Date: November 10, 2020  
Project #: 14009.00 Sudbury to Hudson

## Memorandum

From: Mark Costa, P.E.  
Kenneth Staffier, P.E.  
VHB

Re: Horsley Witten Group: Peer Review of the Stormwater Management  
for the Sudbury-Hudson Transmission Reliability and Mass Central  
Rail Trail Project

## Design Point and Watershed 5.14

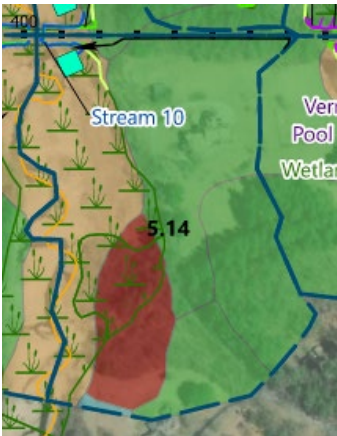
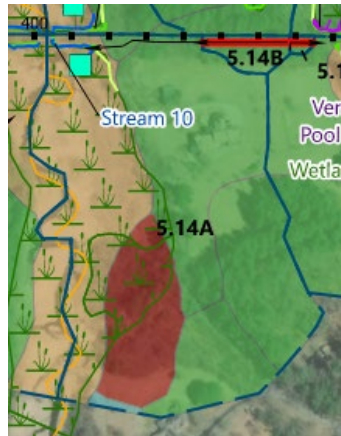
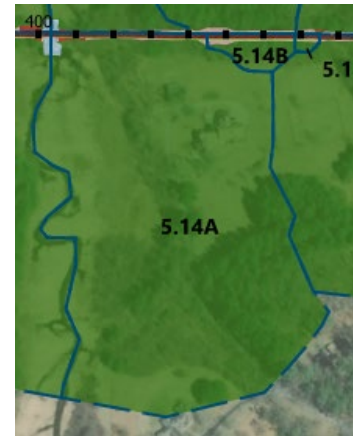
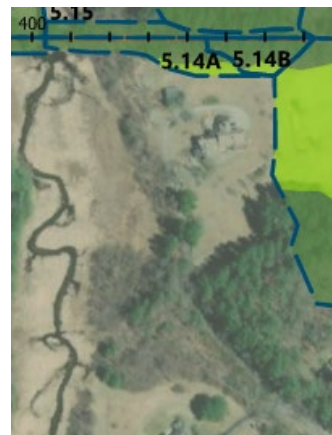
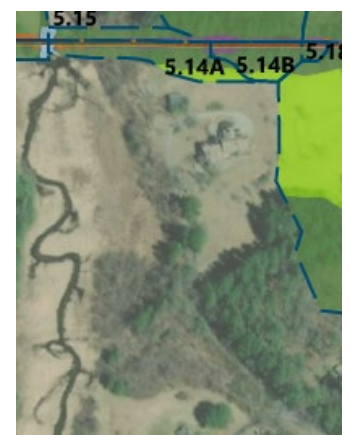
- Existing conditions watershed separated into watersheds 5.14A and 5.14B to create congruency from existing condition watershed to proposed condition watershed. This reduced TCs in the modified existing watersheds which increased peak runoff rates and volumes in the existing conditions.
- Modified delineation of watershed to remove downgradient areas. This significantly reduced peak runoff rates and volumes in both existing and proposed conditions. *BETA Comment SW12.*
- Cover Type area previously designated as Wood - Good to Grass - Good was revised to more accurately reflect the existing cover type.

## Design Point and Watershed 8.5

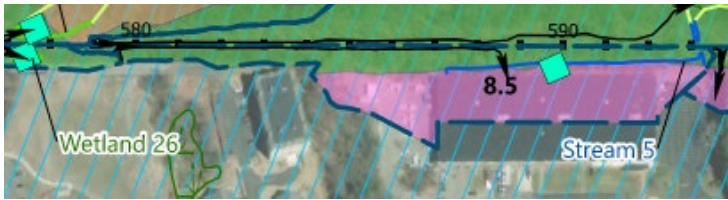
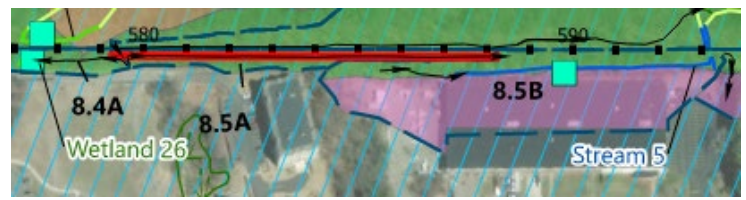
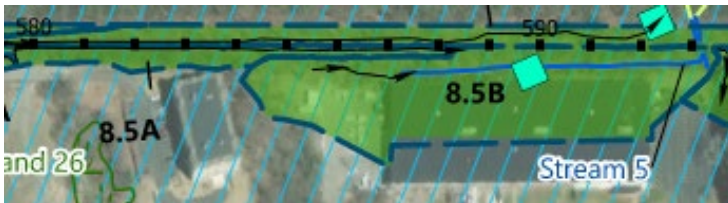
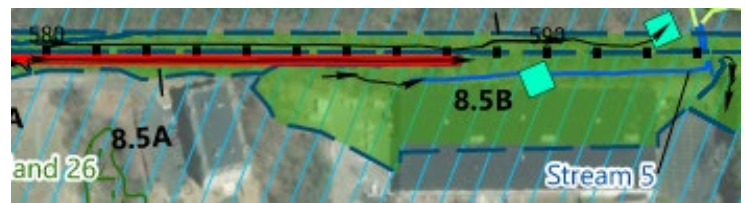
- Existing conditions watershed was separated into watersheds 8.5A and 8.5B to create congruency from existing condition watershed to proposed condition watershed. This reduced TCs in the modified existing watersheds which increased peak runoff rates and volumes in the existing conditions Rev 2.
  - HSGs originally designated as Unknown, were HSG D in Revision 1, and have been updated to HSG A for Revision 2. This reduced the peak rate of runoff and volume in existing and proposed conditions Rev 2.
- BETA Comment SW14*

## Design Point and Watershed 9.1

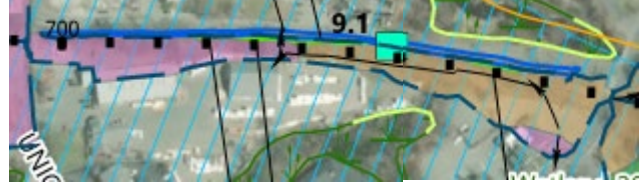
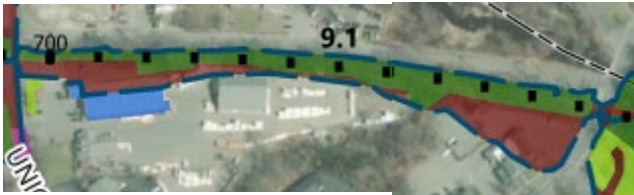
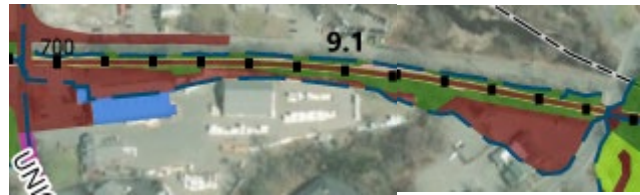
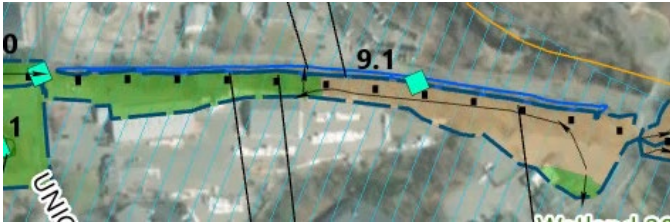
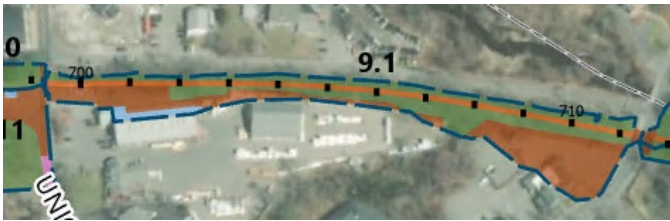
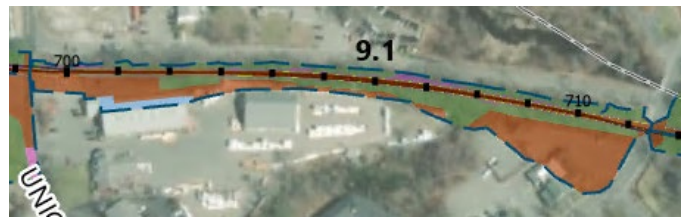
- HSGs originally designated as Unknown were HSG D in Revision 1 and have been updated to HSG A for Revision 2. This reduced the peak rate of runoff and volume in existing and proposed conditions Revision 2. *BETA Comment SW14*
- Portions of the existing rail bed had been designated as Woods – Good cover type within Revision 1. This has been updated to Gravel for Revision 2. This increased the peak rate of runoff and volume in existing conditions Revision 2.

## Design Point and Watershed 10.4

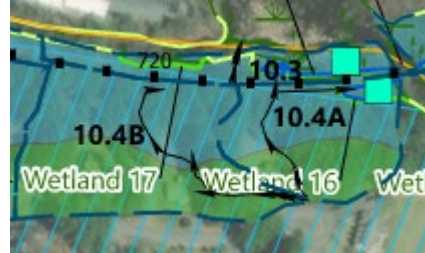
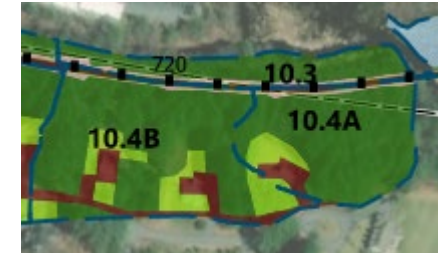
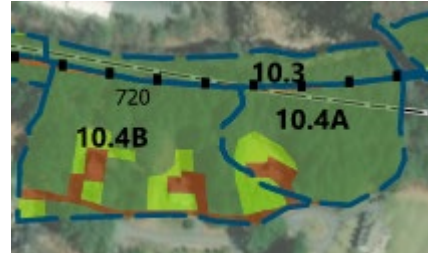
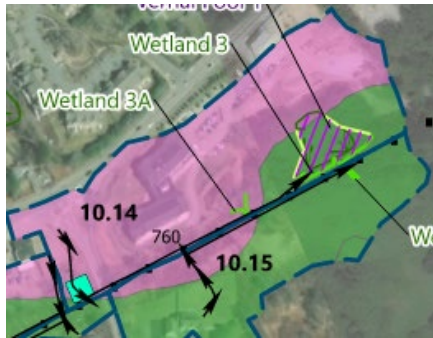
- Existing conditions watershed was separated into watersheds 10.4A and 10.4B to create congruency from existing condition watershed to the proposed condition watershed. This reduced TCs in the modified existing watersheds which increased peak runoff rates and volumes in the existing conditions.
- Added low point in existing and proposed HydroCAD model. This reduced the peak rate of runoff in existing and proposed conditions in Rev 2.
- Added Stone Protection at the end of the conveyance swale in watershed 10.4A *BETA Comment SW10*

## Design Point and Watershed 10.14

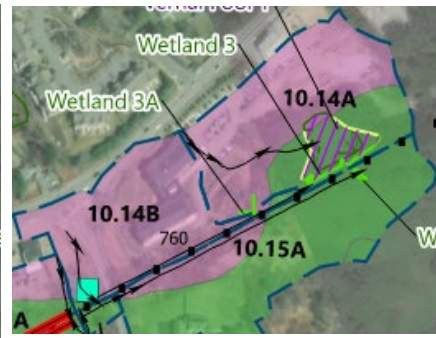
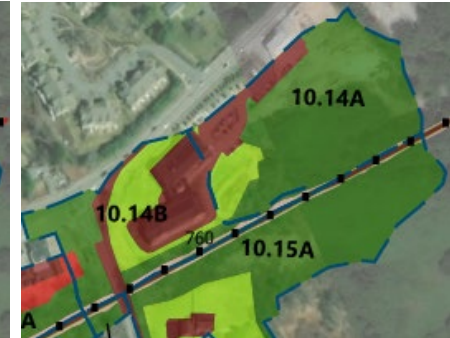
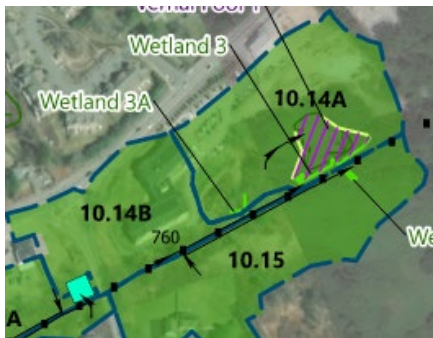
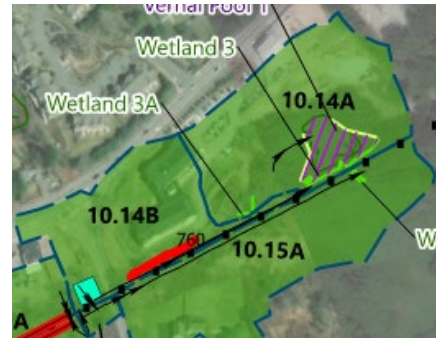
- Addition of Landham Road basin, BMP: P-10.14B. *BETA Comment SW 8* This reduced the peak rate and volumes in proposed conditions Rev 2.
- Existing conditions watershed separated into watersheds 10.14A and 10.14B to create congruency from existing condition to proposed condition. This reduced TCs in the modified existing watersheds which increased peak runoff rates and volumes in the existing conditions.
- HSGs originally designated as Unknown were HSG D in Revision 1 and have been updated to HSG A for Revision 2. This reduced the peak rate of runoff and volume in existing and proposed conditions Rev 2. *BETA Comment SW14*.

- Existing cover type for bike path updated from Gravel to Brush – Poor. This decreased peak rate of runoff and volume in existing conditions Rev 2.  
*BETA Comment SW1*
